4.0 SITE ANALYSIS

4.9 ACOUSTICS

4.9.1 KEY ACOUSTIC ISSUES AT DD

Figure 4

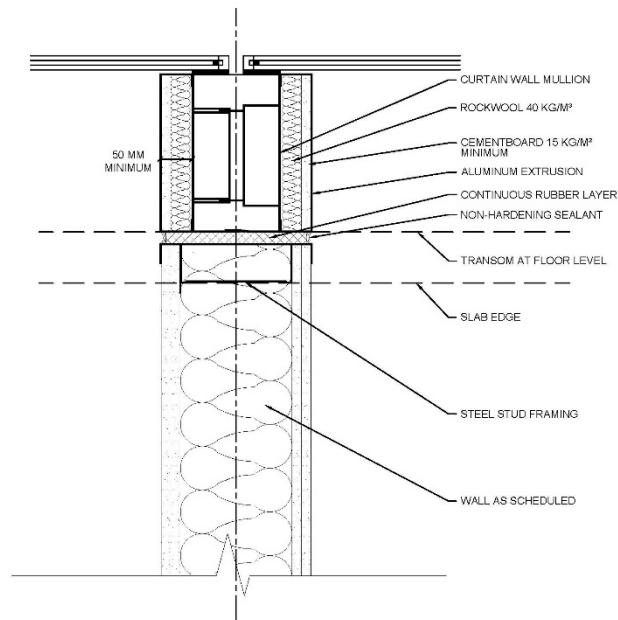
** One option is to use the “Mull-it-over” product – see figures on following page. A second option is to develop and extrusion detail that is included in the curtainwall scope.

50%CD Update: The conference room and seminar room mullion detail does not include a cover plate or packed mullion detail. The flanking noise performance is not expected to meet the targets set out in the table above by approximately 5 – 10 dB.

Figure 6

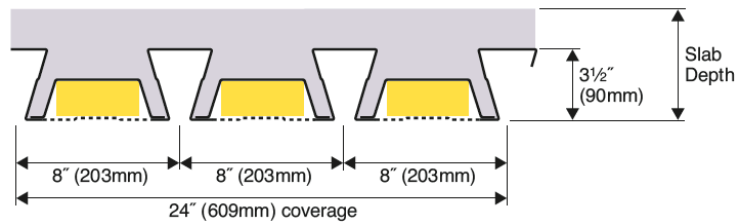
50%CD Update: Architect confirmed use of Epicore.

Figure 7

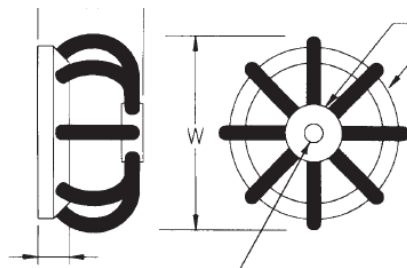
Options 1 and 2 will be studied by Arup and Morphosis in the next phase.

50%CD Update: It is understood that basketball will not be a primary function for the multi-purpose room and that the floor for this room does not need to be

Markups of partitions types and locations are shown below:

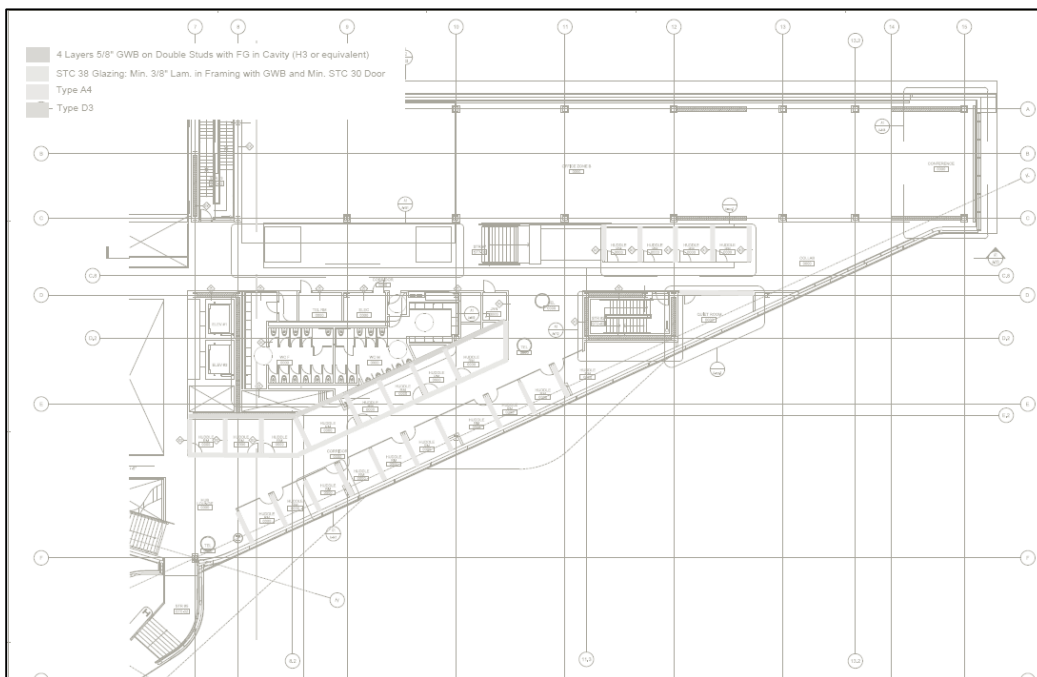
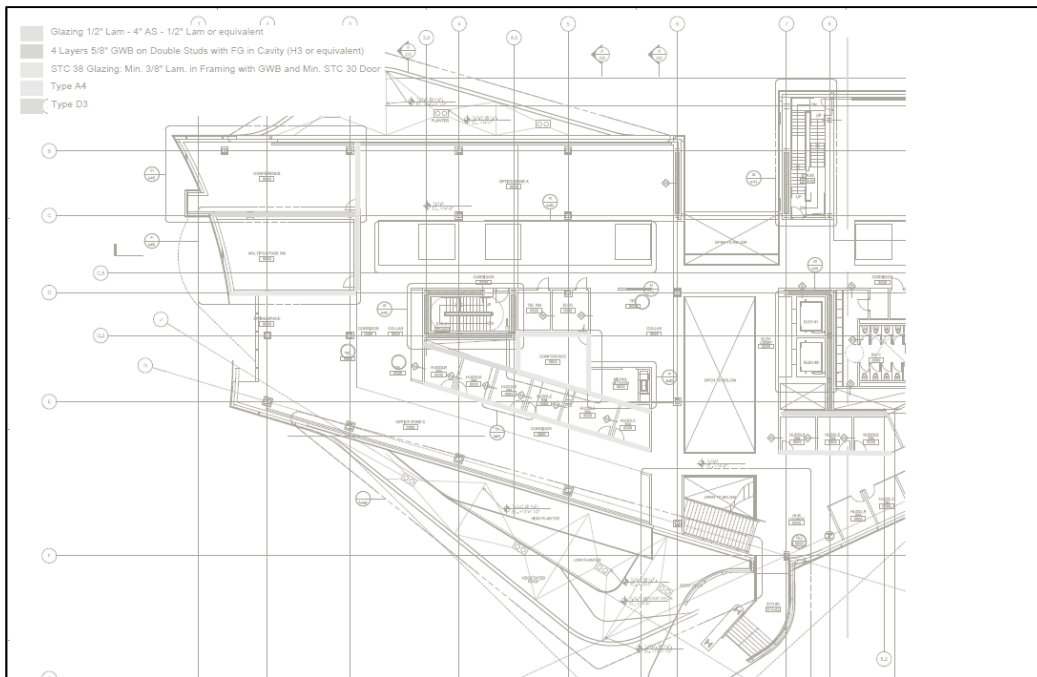
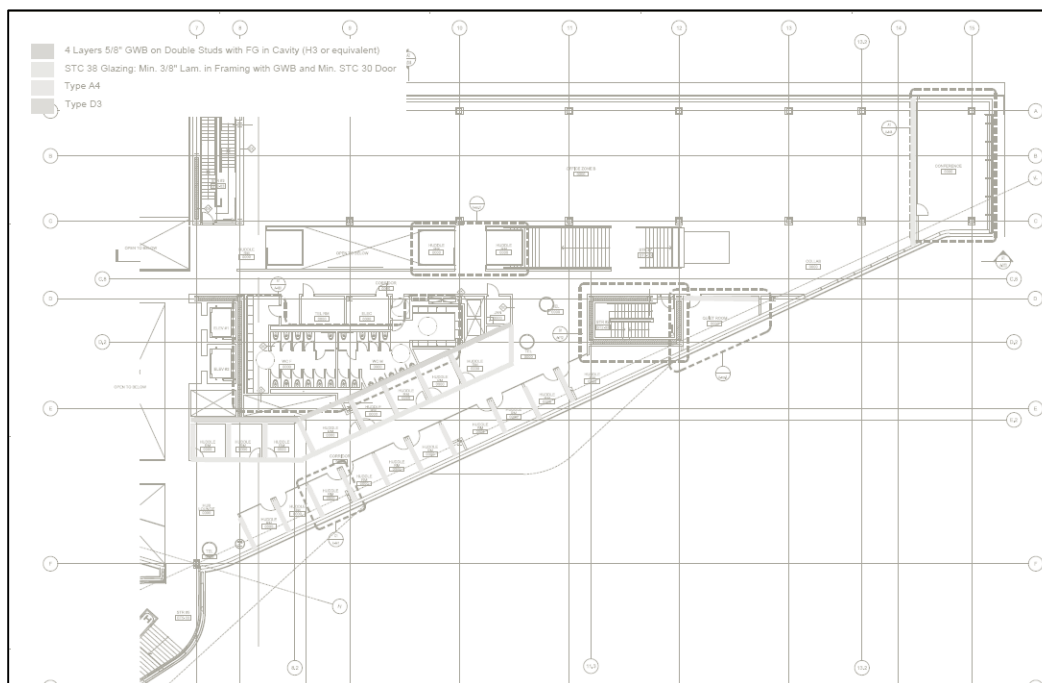
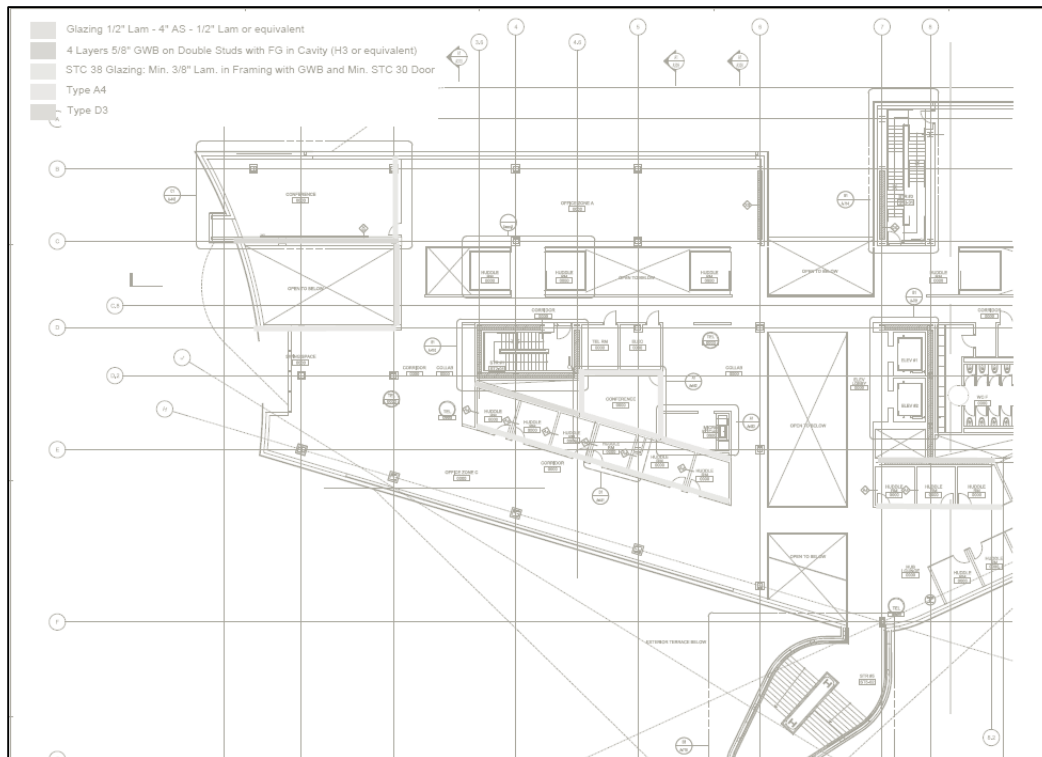
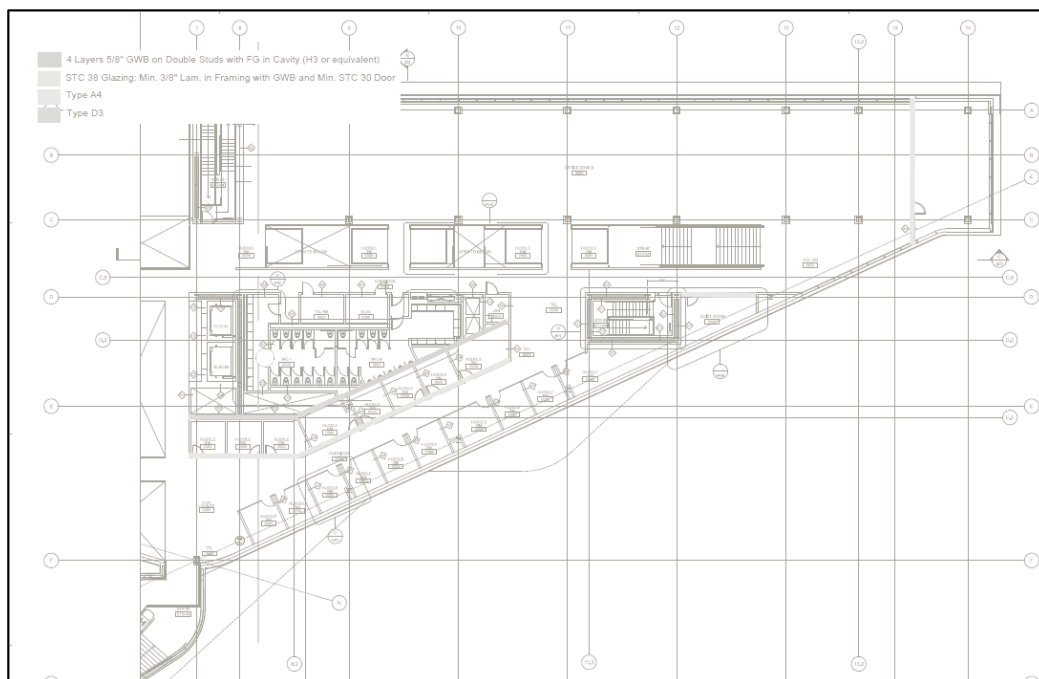
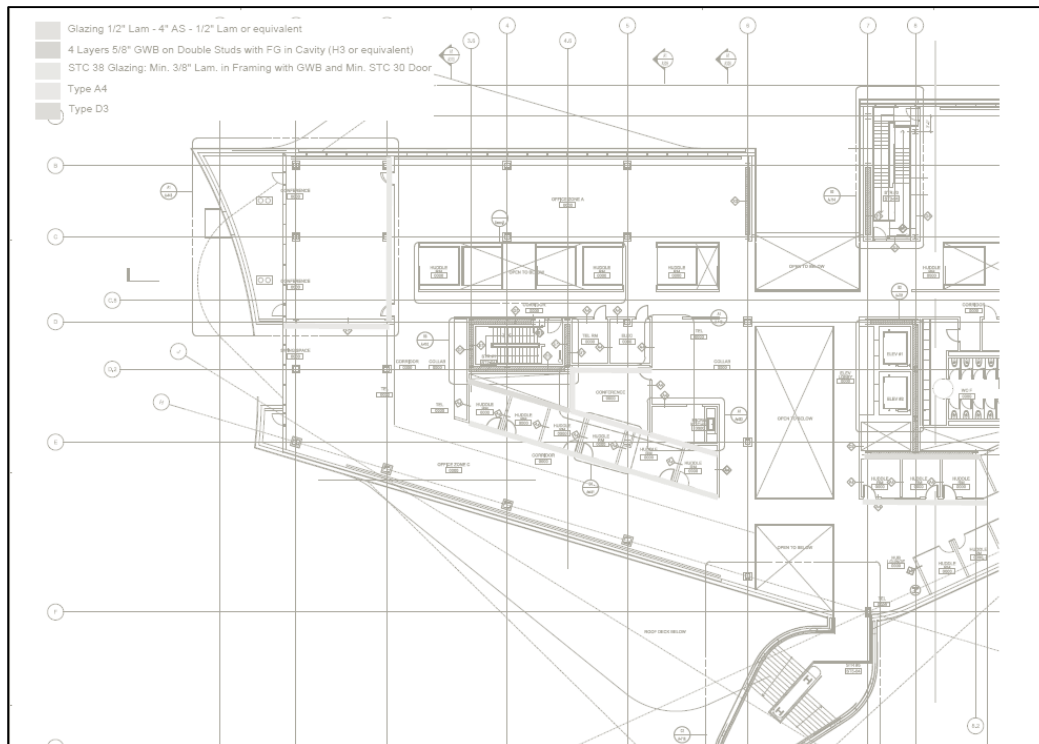
50%CD Update: Updates to partition types were outlined in Arup 100%DD acoustic markup dated 11/19/2013.

100% CD Update: all images relate to 50% CD or earlier – recommended locations have been incorporated into 100%CD Architectural Drawings.

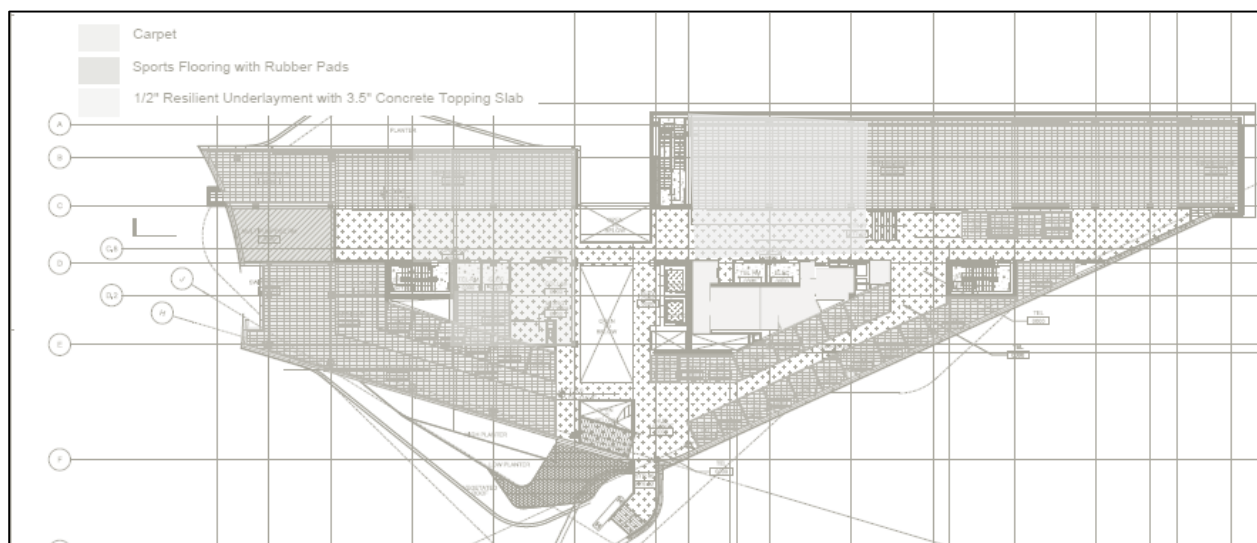
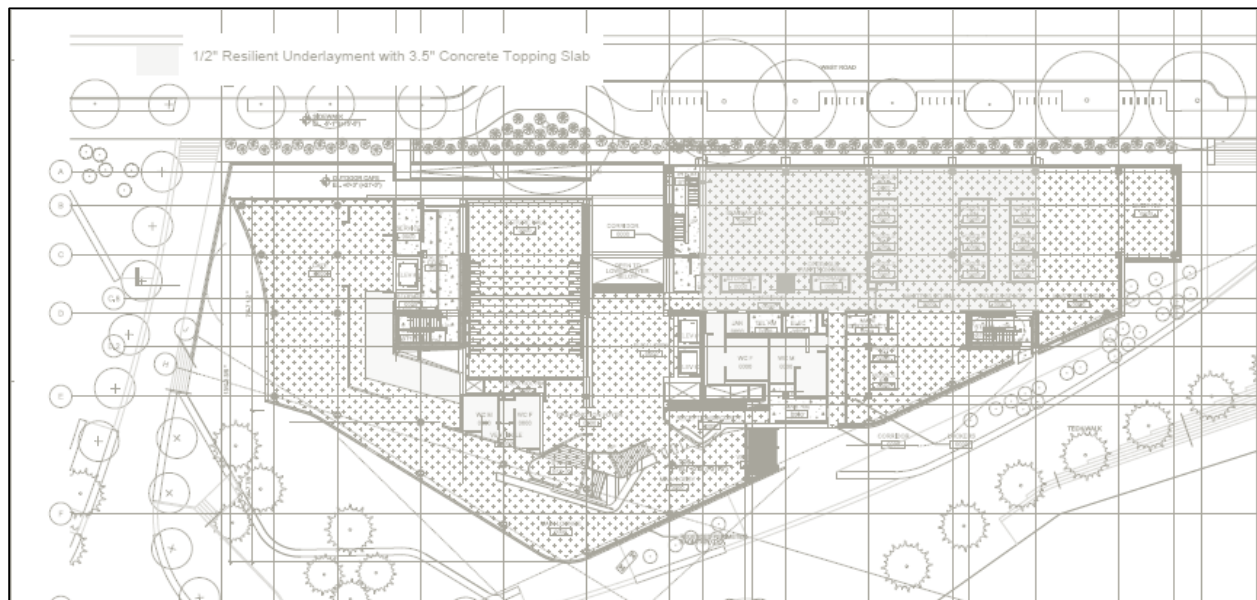
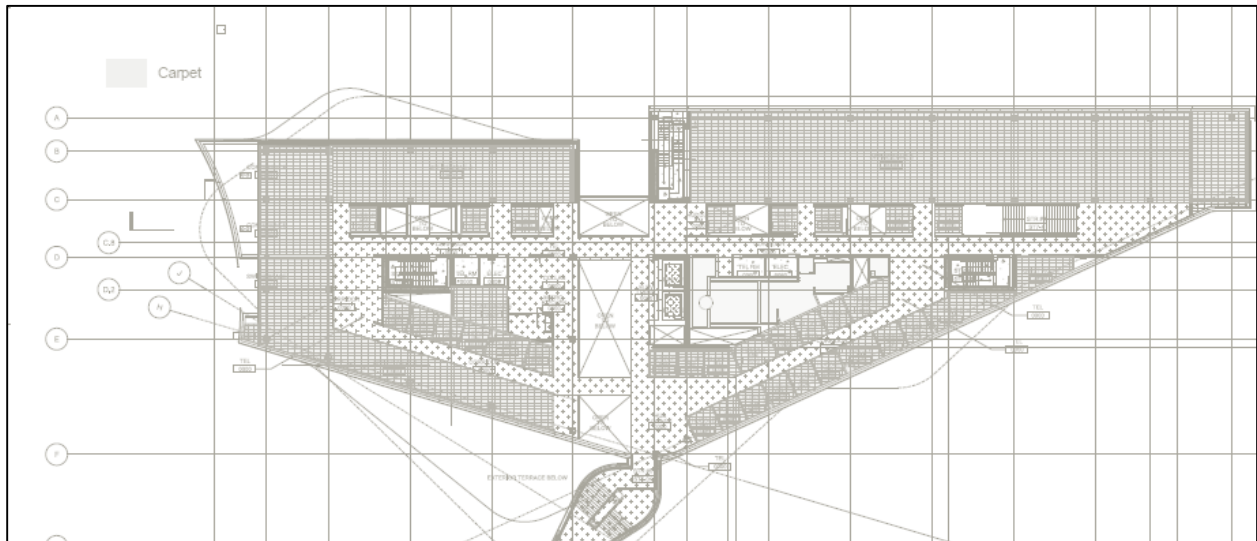
50%CD Update: The hard floors above the lecture hall and both levels of seminar rooms include a resilient impact layer to help mitigate footfall.

100% CD Update: all images relate to 50% CD or earlier – recommended locations have been incorporated into 100%CD Architectural Drawings.

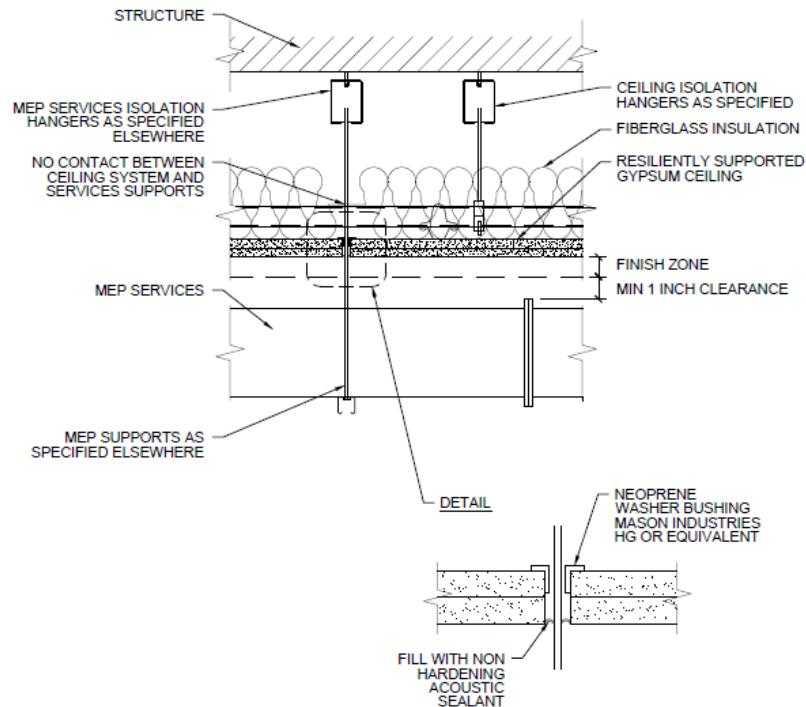
- The basement pump room should have approximately 50% of the walls and ceilings treated with 2-in thick perforated metal sound absorbing panels with bagged-fiberglass backing. Kinetics Noise Control KNP panels or equivalent. Alternatively, black tissue faced fiberglass may be used.
- Doors should be minimum STC45 steel doors.

100% CD Update: Hollow metal doors and metal door frames will be packed with fiberglass insulation to prevent sound transmission and flanking.
